GIRDER
VT 78 OVER MISSISSQUOI BAY, BRIDGE NO. 2
VT 78 STA.10+970.425 TO STA.12+059.775
TOWNS OF ALBURG AND SWANTON
COUNTIES OF GRAND ISLE AND FRANKLIN
STATE OF VERMONT, AGENCY OF TRANSPORTATION

STATE CONTRACT OR REF. NO. BRF-036-1(1)
CONTRACTOR CIAMBRO CORPORATION
IN CHARGE: GLIDDEN (IH)
CONTRACT NUMBER: VT-04057-3

MADE BY: SSL
CHK'D. BY: CS
DATE: 8-24-04
DRAWING NUMBER: 77 OF 112

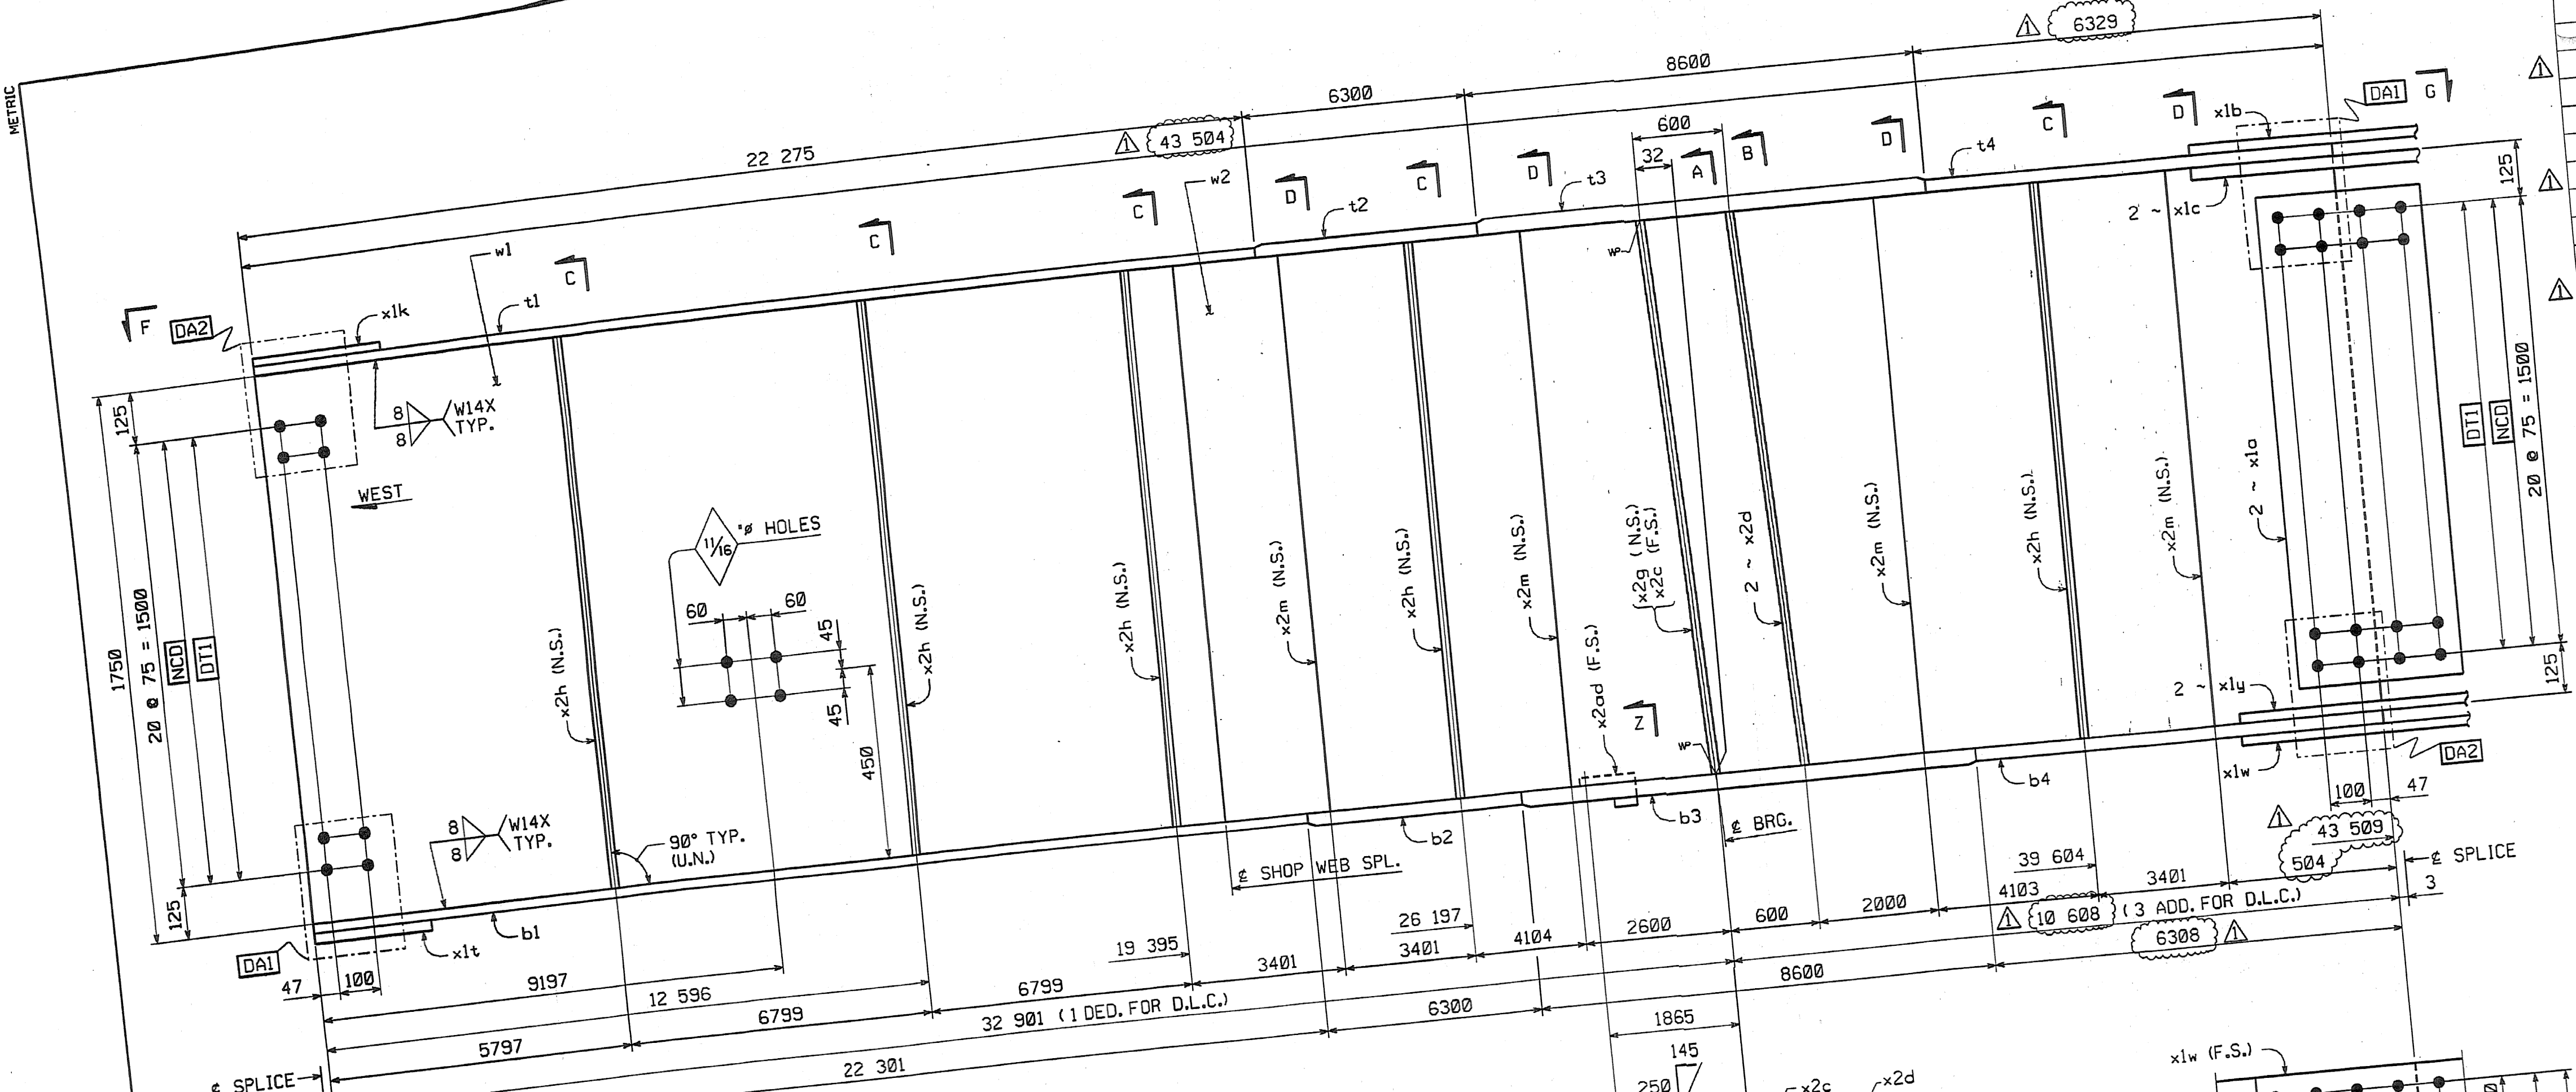
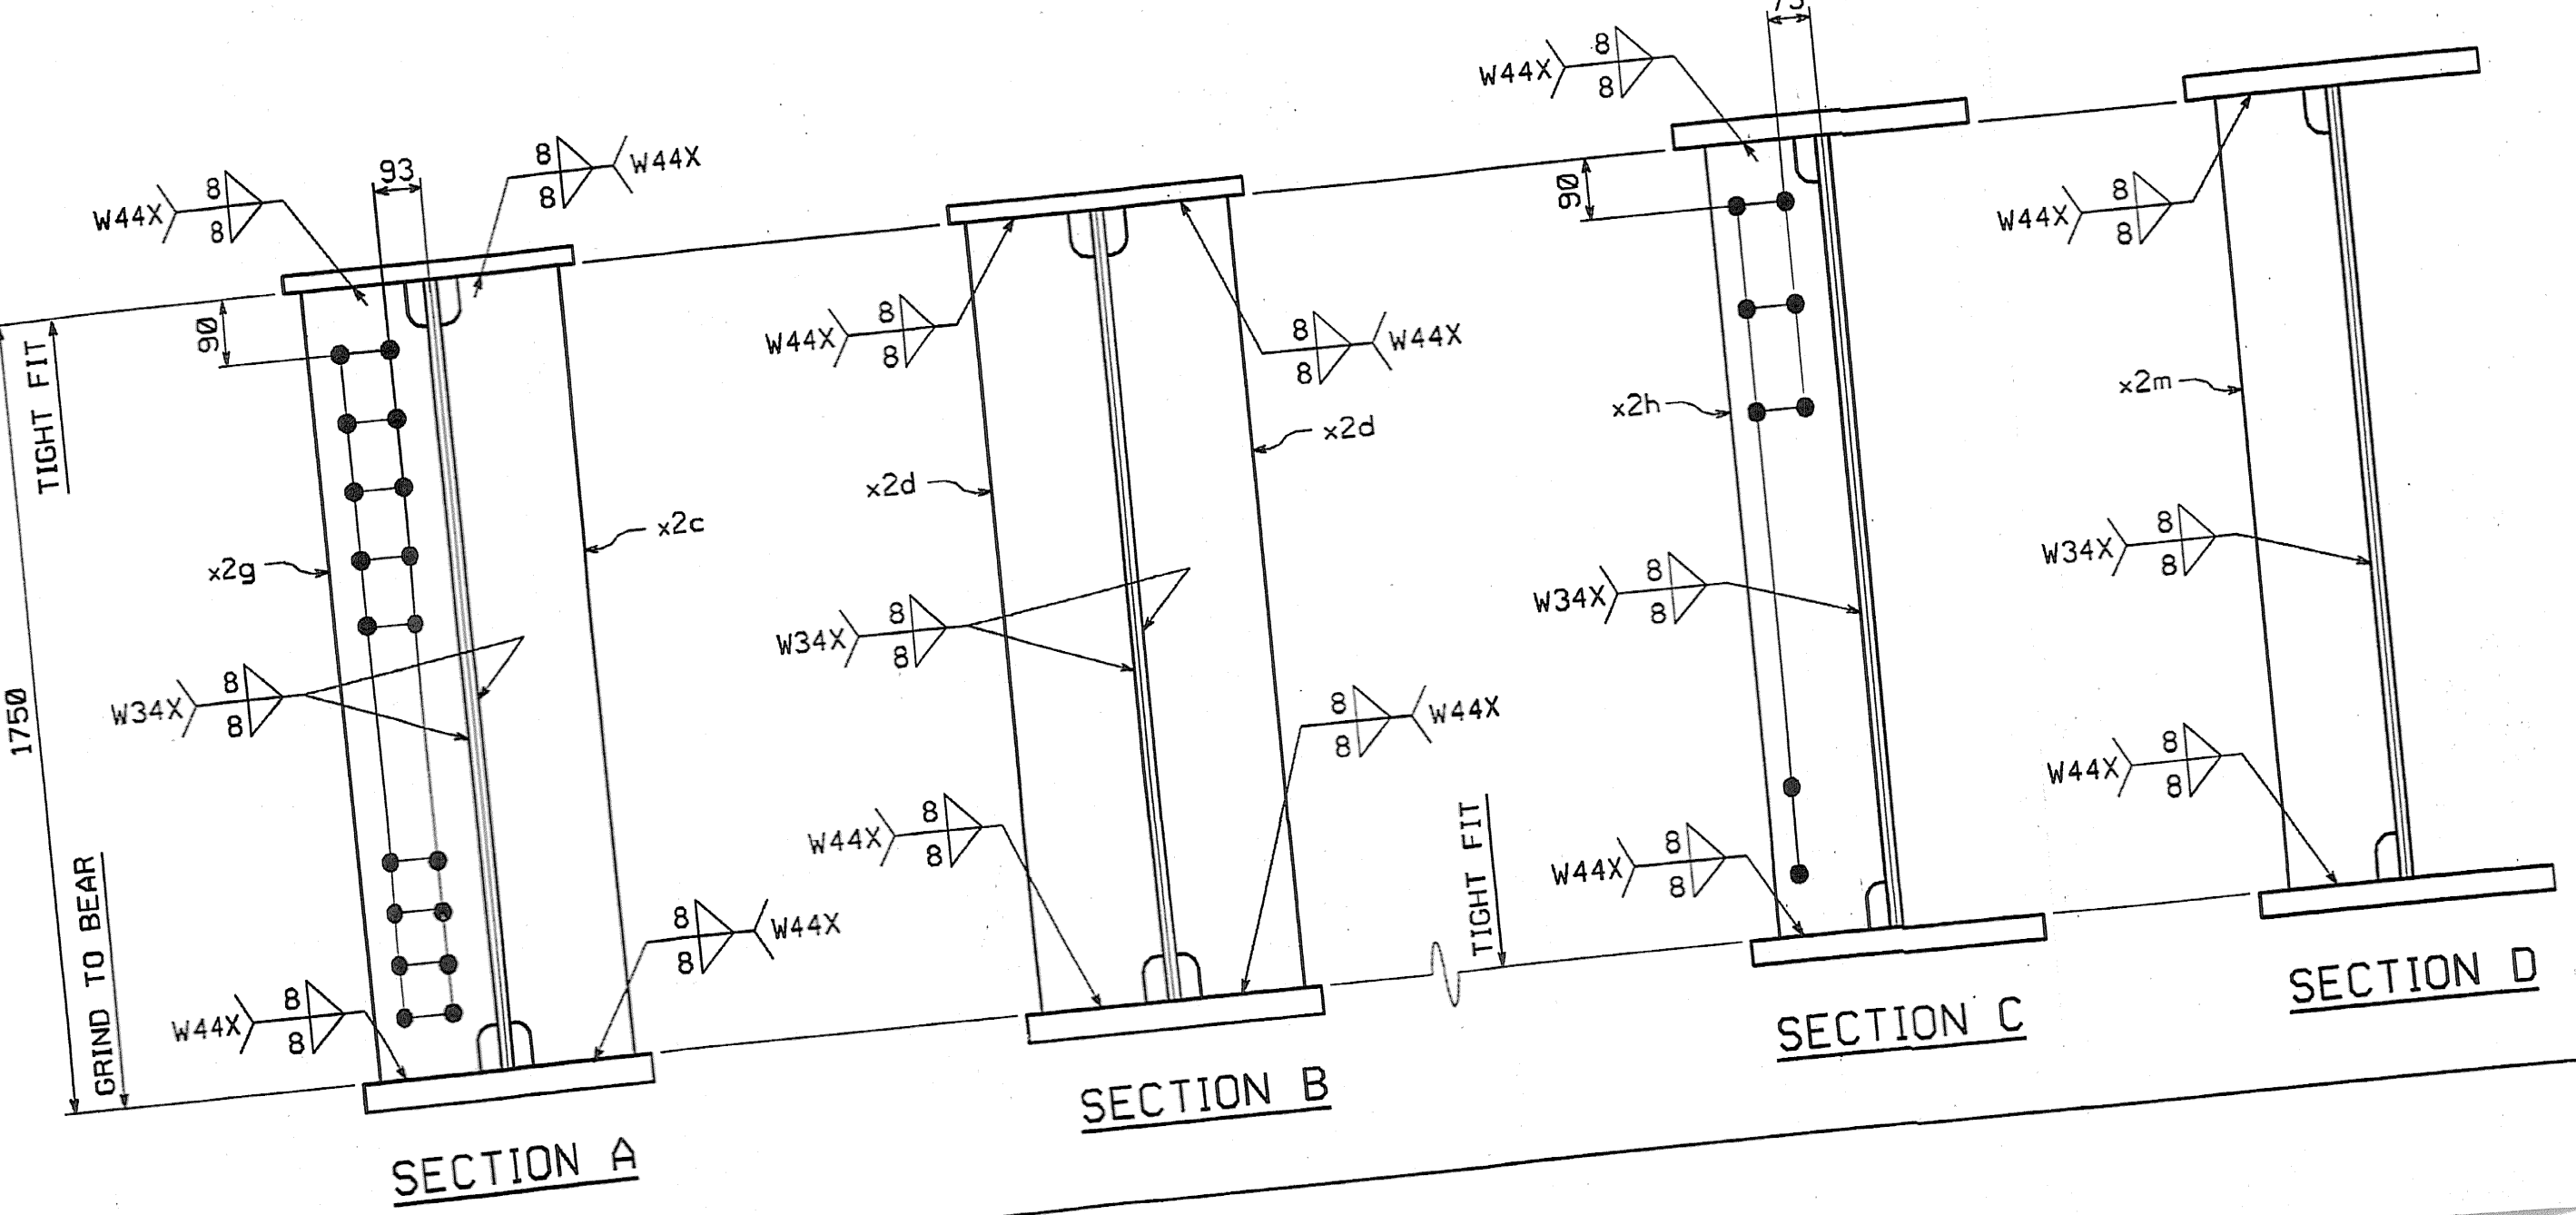
NO.	REVISION	DATE
1	INCREASE LENGTHS TO SATISFY REQUIREMENTS FOR LENGTH & MEAN TEMPERATURE OF 45°F.	9/20/04
